SW Compost  
Permit # 19-06  
McGill

Re: McGill Environmental Systems – SWC-19-06 Permit Modification

RE: Request for additional information on proposed biofilter.

# CROSS-SECTION

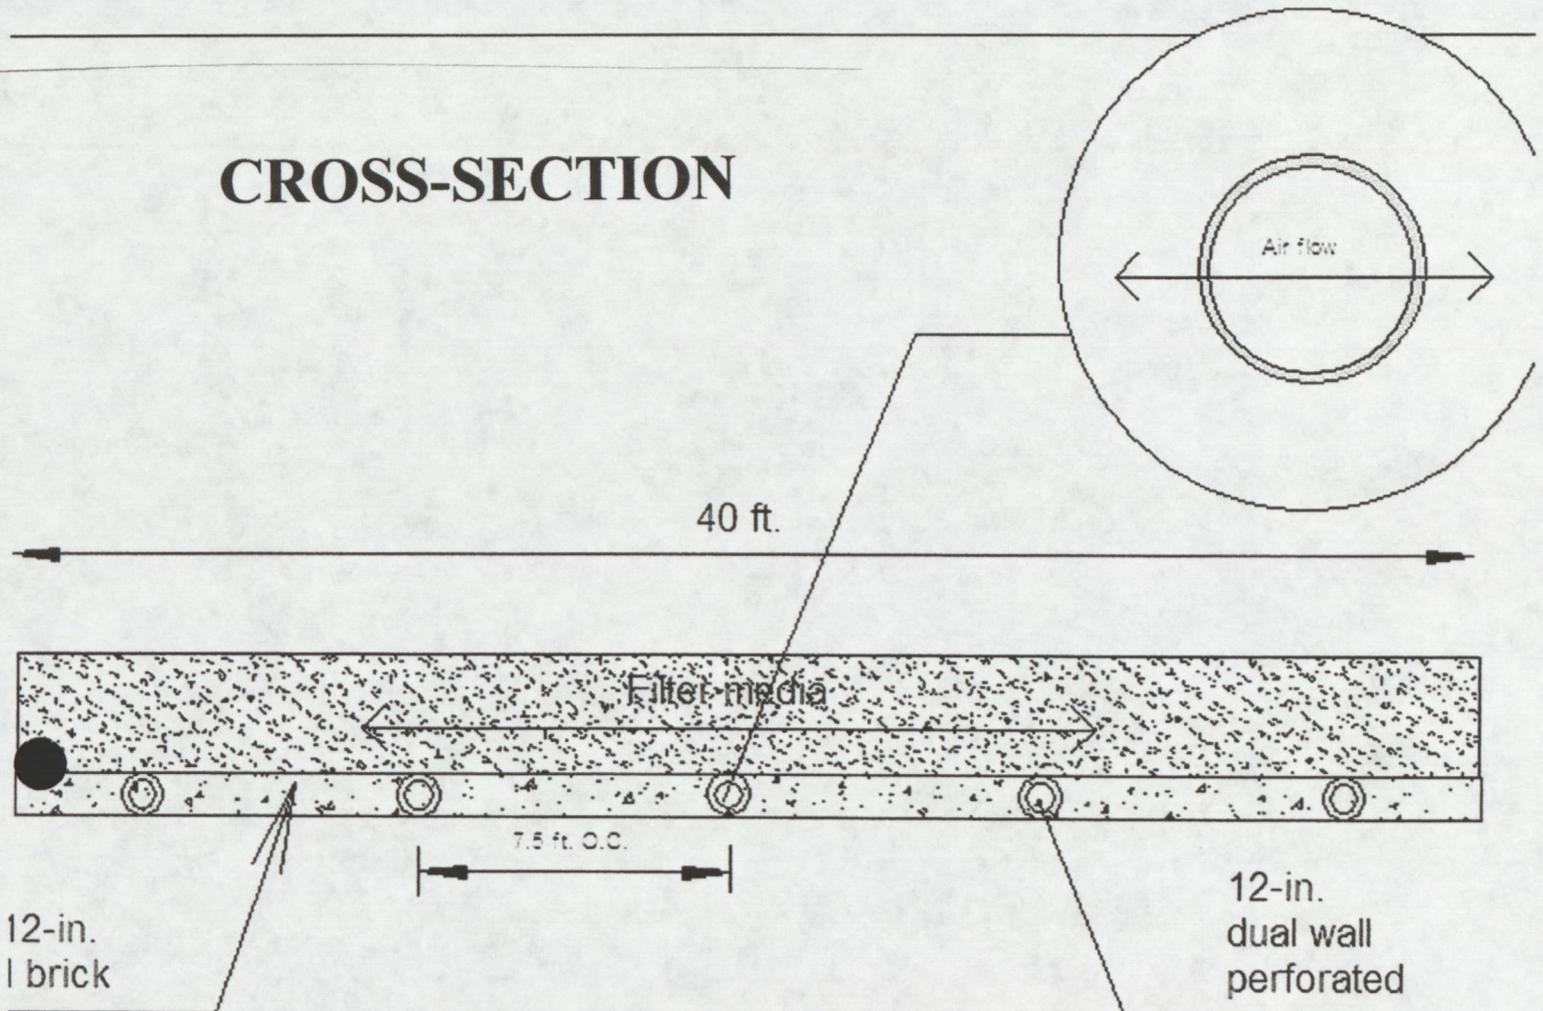
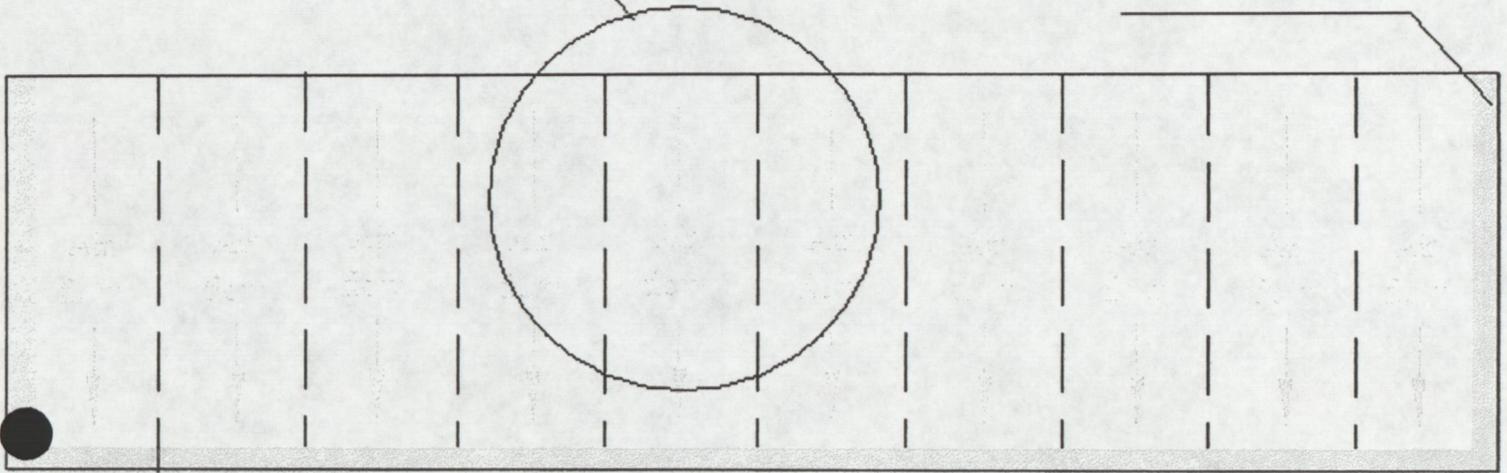
1. With the average brick size of the brick around the pipes is 4 inches. Does this large a particle create the possibility of material sifting down and restricting airflow?
2. It appears that your media is going to be 80% inert and 20% compost. With this much inert material is there not a risk of a significant delay in the media being effective? With this size material is there a risk of the 20% compost sifting down and reducing effectiveness or restricting air flow.
3. What is the retention time or CFM/square foot for the biofilter.
4. There are other means of managing leachate from the biofilter. You could for example collect it and manage it with the compost. This would require that you design and install some type of collection system. We would of course need to review the plans for the collection system.

I am well aware that wood does not behave as an inert material. Item #3 in your letter to us indicates that the media will contain inert material and 20% compost. There is no mention of wood chips being in the media. There is a mention of screened material from the existing media being used, but that is in reference to the perimeter.

- 1) The brick will be an average size of 4 inches. Optimal lateral air movement will be achieved by using the brick, which is considerably more porous than the media. The existing low permeability pad will remain in place under the biofilter.

- 3) The media will be extended 42 inches from the air outlet point. The additional 6 inches will permit better air movement through the brick material prior and up through the media. The inert media, composed of crushed brick or rock of particle size 3 inches or less, will serve similar functions to those now served by woodchips. One function is that of bulking agent, but with the advantage of longer life than woodchips. Another function is to provide surface area for colonization by microbial populations. Inert media, though lacking in nutrients, are common in biofilters. In

5) The material used on the perimeter will be screened existing media, applied to a 12-inch thickness. This material is much finer, will seal the sides and improve the appearance of the finished biofilter.

- 1 The proposed brick base will not restrict airflow. We know this from our observations of the existing media over the past almost 3 years. During that period the finer material which included 20% compost did not restrict airflow above the back pressure created by the blowers even though it was placed directly on the piping. In fact we expect the brick to contribute greatly to maintaining a more porous environment in the lower section of the biofilter for a longer period of time thus further delaying settling of media that occurs in all biofilters.

- 2 Wood does not behave as an inert material in a biofilter. Older ground woodchips will already contain the microbial populations and the energy necessary to support such populations. Additionally much of the wood to be used will come from screening the existing media therefore making it the most specifically acclimatized material to treat this airstream. The media will be mixed in advance therefore all ingredients will be well inoculated in advance of placement on the biofilter.  
The scheduled change will act as a further protection in that the sections will be changed over a number of weeks.

- 3 The retention time will be at 45 seconds.
- 4 We continue to look at various options for leachate management. We are not ready at this time to submit a change request. Over the coming months I want to examine mechanisms of leachate management at other solid waste composting facilities for possible cost effective options. We will also evaluate the collection option.

Wood chips	60 - 65%,
Compost	20%
Inert materials	15 - 20%
